PLUS7 Fuel Design for the APR1400

APR1400-F-M-TR-13001-NP-A

| A | Letter from William Ward(NRC) to Han-Gon KIM (KHNP), ADVANCED POWER REACTOR 1400 FINAL SAFETY EVALUATION FOR TOPICAL REPORT APR1400-F-M-TR-13001-P,REVISION 1, “PLUS7 FUEL DESIGN FOR THE APR1400,” dated on May 25, 2018. |

SUBJECT: ADVANCED POWER REACTOR 1400 FINAL SAFETY EVALUATION
FOR TOPICAL REPORT APR1400-F-M-TR-13001-P, REVISION 1,
"PLUS7 FUEL DESIGN FOR THE APR1400"

Figure 2-1 PLUS7 Fuel Assembly Configuration

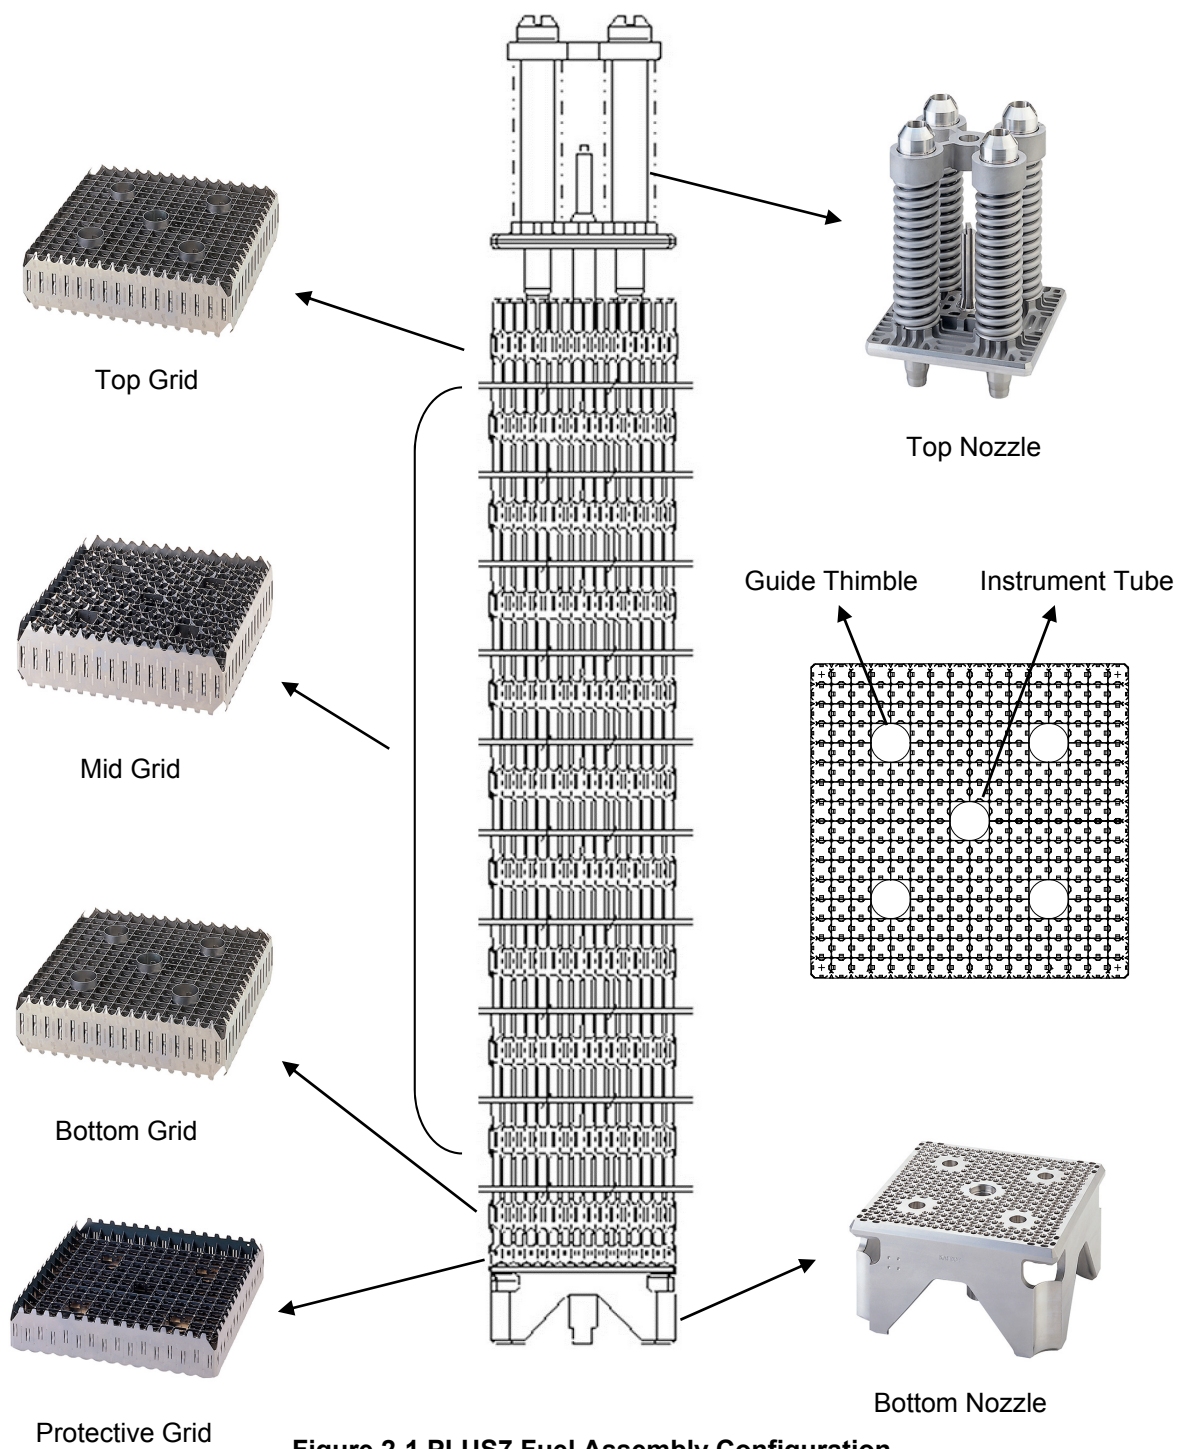
In Section 2.3.4, Figure 2-1, and Figure 2-17 of APR1400-F-M-TR-13001, Revision 1, the applicant presented a description of the guide thimbles and instrument tube. The staff finds that the guide thimble and instrument tube spring design has been adequately defined in the TR such that an analysis of the proposed methods may be performed.
